AMENDMENT NO. 3 JULY 2015
TO
IS 694 : 2010 POLYVINYL CHLORIDE INSULATED UNSHEATHED AND
SHEATHED CABLES/CORDS WITH RIGID AND FLEXIBLE CONDUCTOR FOR RATED
VOLTAGES UP TO AND INCLUDING 450/750 V

(Fourth Revision)

Amendment No. 3 to IS 694 : 2010

FIG. 1 PREFERRED ARRANGEMENT OF MARKING

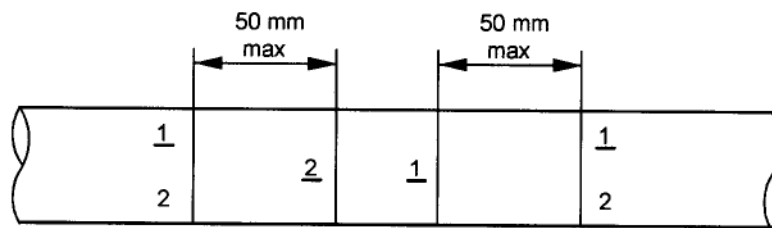
(Page 6, Fig. 1) — Substitute the following 'Fig.1' for the existing:
